FIAT CHRYSLER AUTOMOBILES

Campaign T59 - Brake Booster on 11-14 WK/WD

Summary of T59

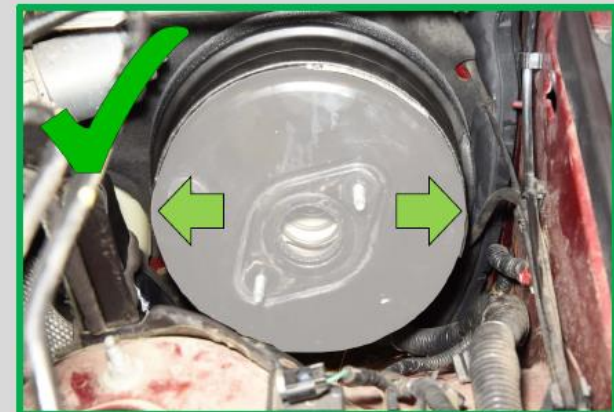
Brake booster water shield must be installed correctly in order to function properly.

1 Tab edges must be flush with edges of the brake booster.

INCORRECT

CORRECT

2 Tabs must be positioned at three o'clock and nine o'clock positions with booster installed in vehicle.
